Palo Verde Nuclear
Generating Station

**Subject: Palo Verde Nuclear Generating Station (PVNGS)
Units 1, 2, and 3
Docket Nos. STN 50-528, 50-529, and 50-530
Request to Amend Technical Specification (TS) 3.8.7, "Inverters –
Operating," to Extend Completion Time for Restoration of an
Inoperable Inverter – Request of Additional Information Response
(TAC Nos. ME2337, ME2338, and ME2339)**

APS Response to NRC Request of Additional Information

LICENSE AMENDMENT REQUEST
TO EXTEND THE COMPLETION TIME IN TECHNICAL SPECIFICATION 3.8.7
FOR RESTORATION OF AN INOPERABLE INVERTER
TAC NOS. ME2337, ME2338, AND ME2339

**Figure 6-1b
 Simplified Level 2 Station Blackout Event Tree**

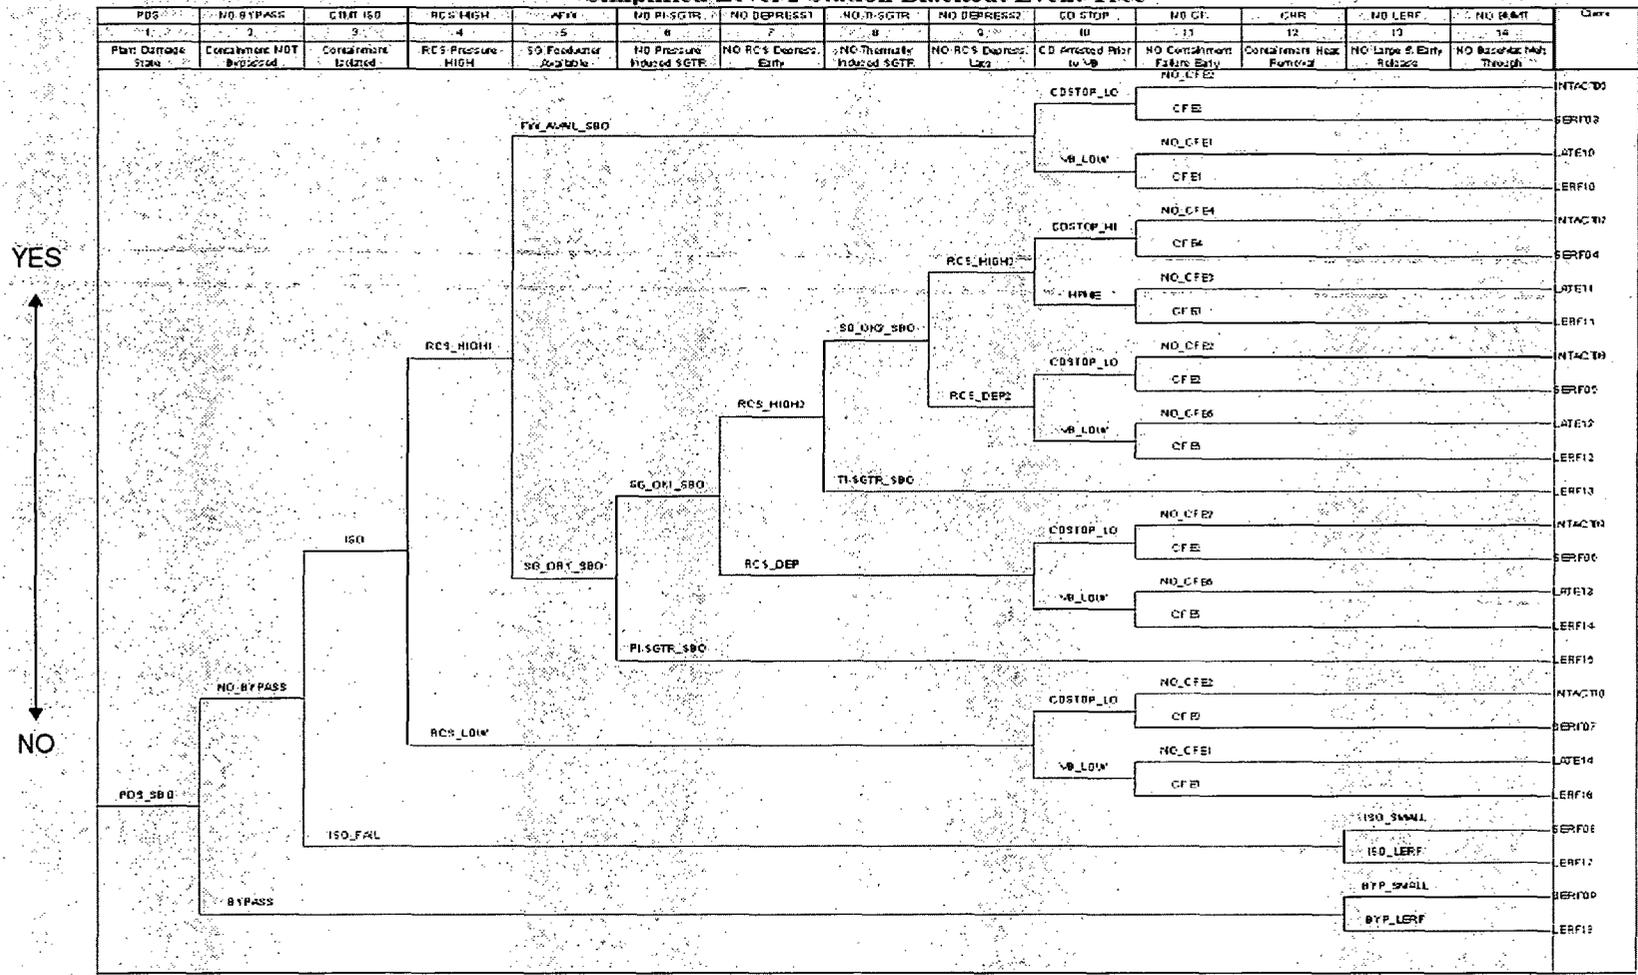
element SR LE-C10. The disposition of this item implies that scrubbing is credited for preventing large releases for steam generator tube rupture, based on an assumed operator response to assure steam generators are water-filled (“flooded”). Describe where the large early release frequency (LERF) analysis credits scrubbing, and provide a basis for this credit.

In 2005, *Westinghouse Electric Corporation* (WEC) completed WCAP-16341-P, *Guideline for PRA Level 2 Analysis*. The new guidelines are designed to meet the ASME Standard, R.G. 1.200 capability category II. In their report, WEC provided plant-specific results on key aspects of LERF modeling parameters including the credit for SGTR flow scrubbing. The new PVNGS Steam Generator design (with pristine tubes, <2.5% plugged) allows for scrubbing credit.

A sample Event Tree from the WEC report is provided below to demonstrate that induced-SGTR questions (6th and 8th) are asked on the tree branches with AFW failure (5th question from the left). The Iodine-free water level above the break location allows for a negligible value of flashing fraction at normal SG water levels. When coupled with required operator action to “flood” the SG, the water level above the break location exceeds 30 feet.

**Simplified One-Line Schematics of the Vital Direct Current System
and the Vital Alternating Current (AC) Instrumentation and Control
Power System**

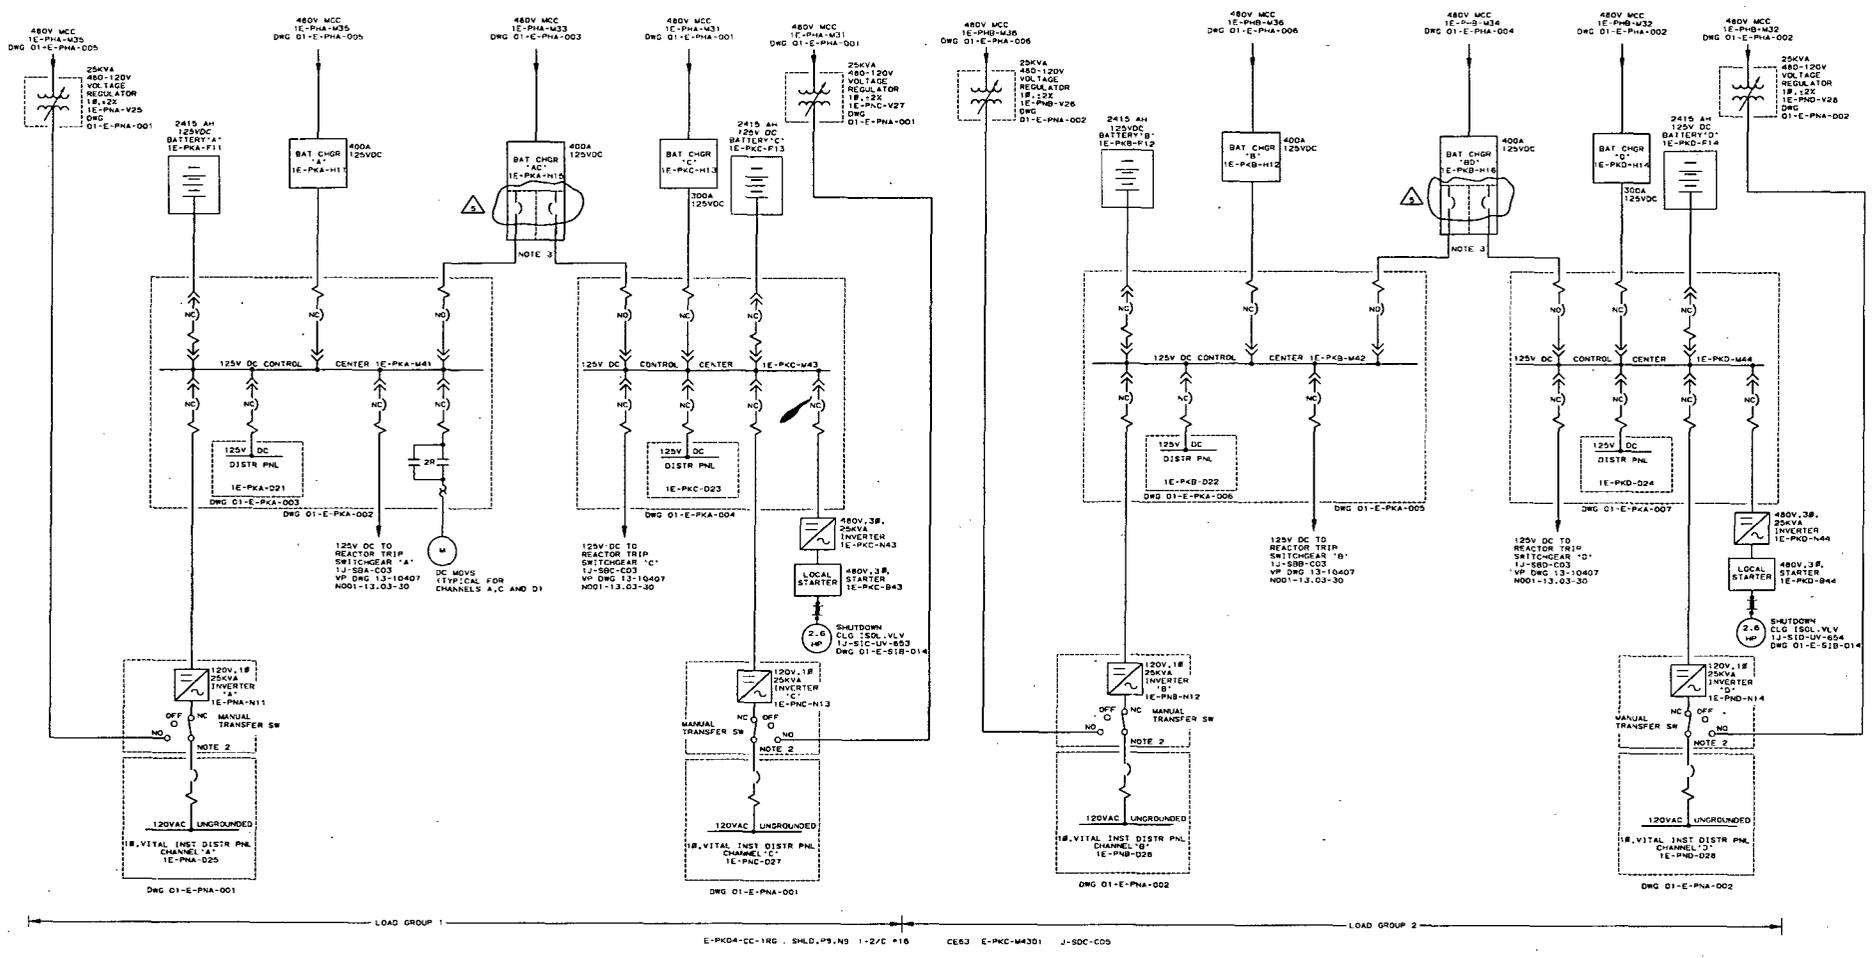
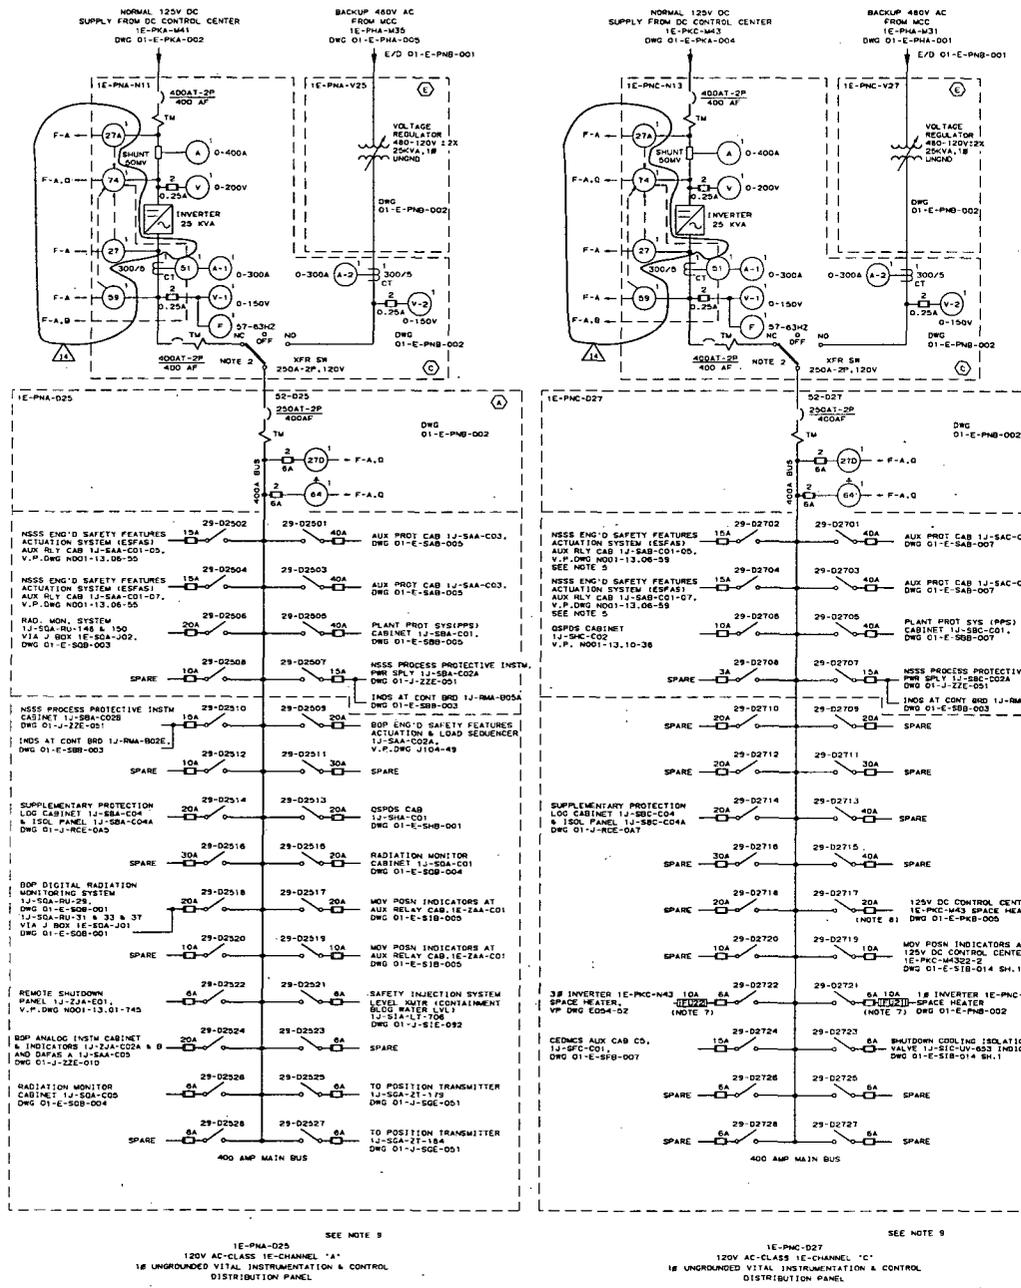
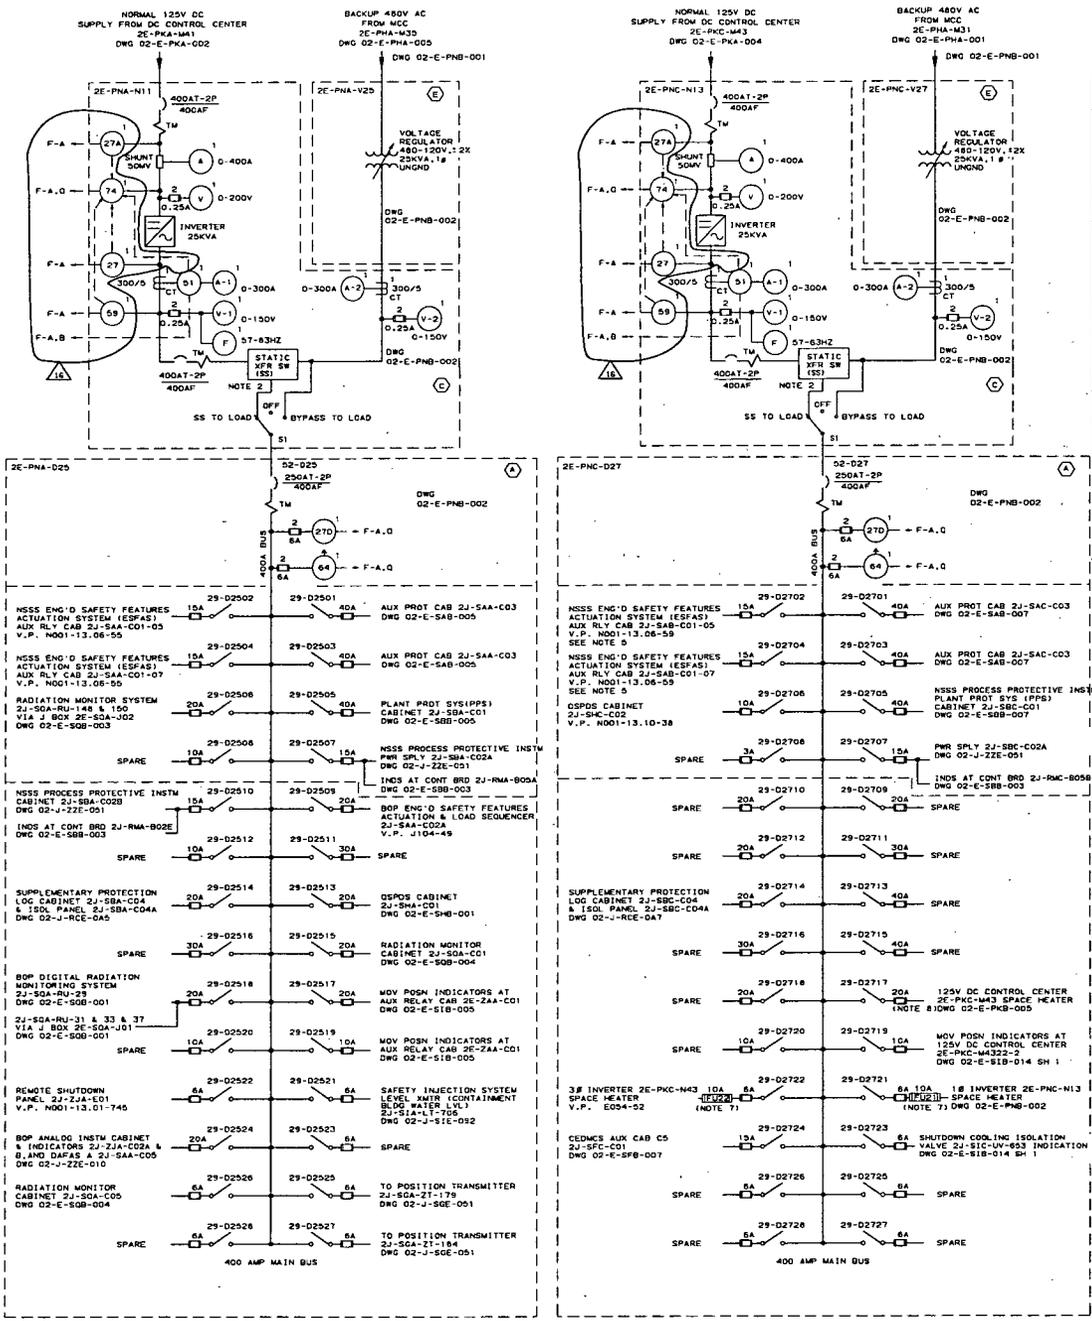
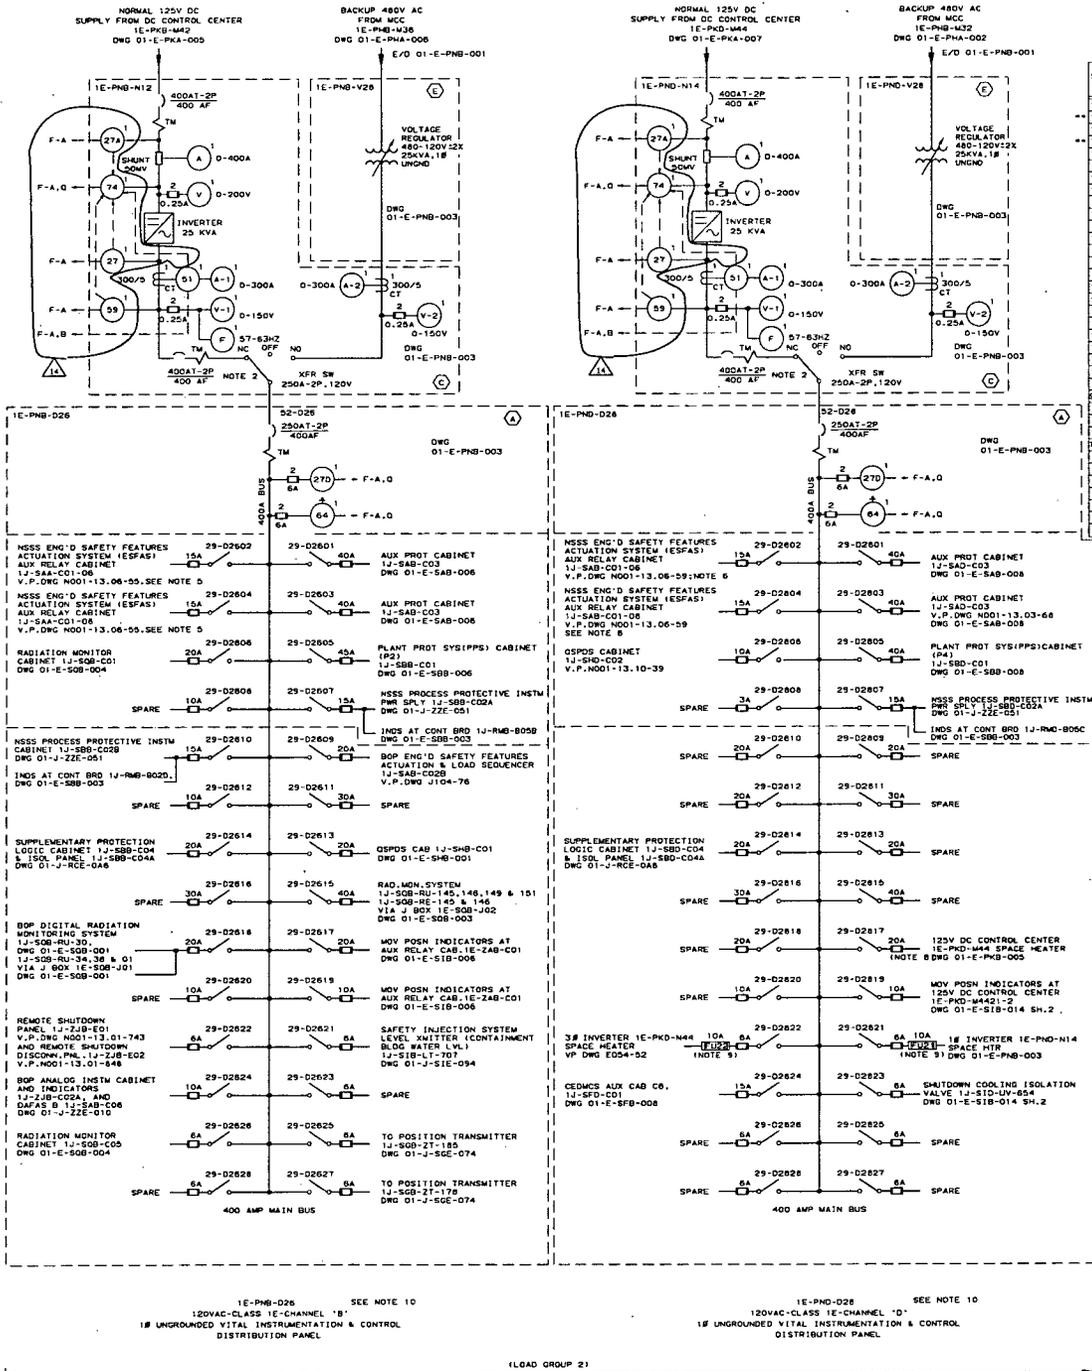
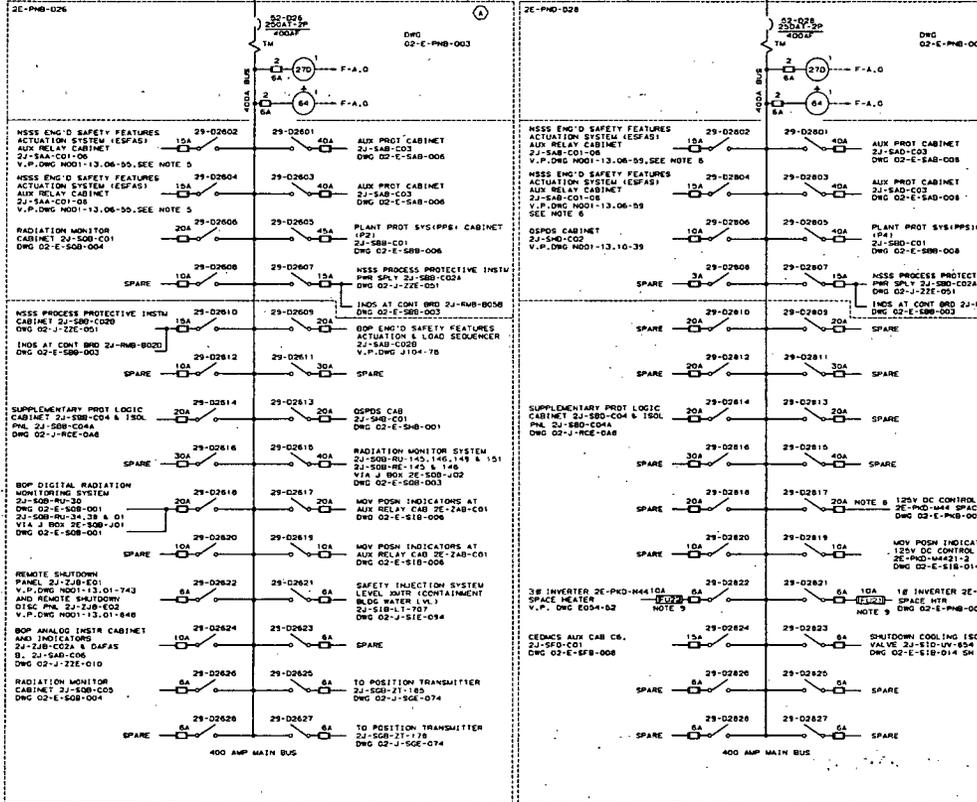
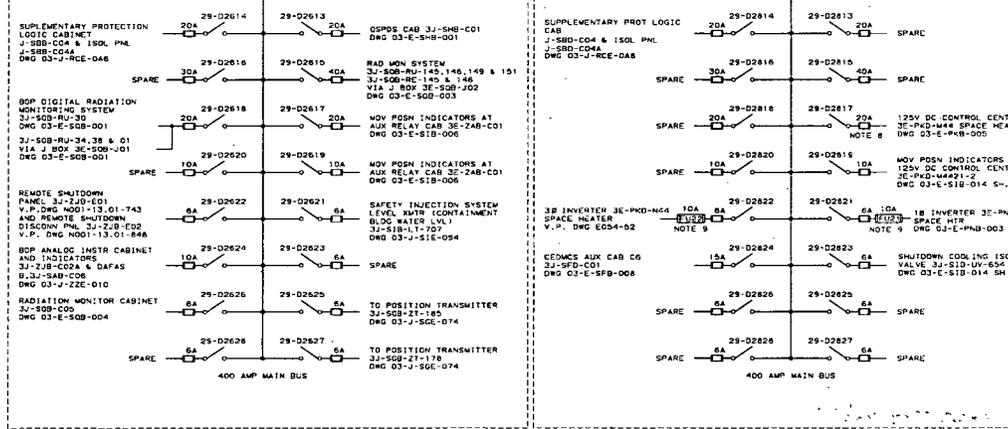
Provide current as-built simplified one-line schematics of the Vital Direct Current system and the Vital Alternating Current (AC) Instrumentation and Control power system including the backup regulated power supply.
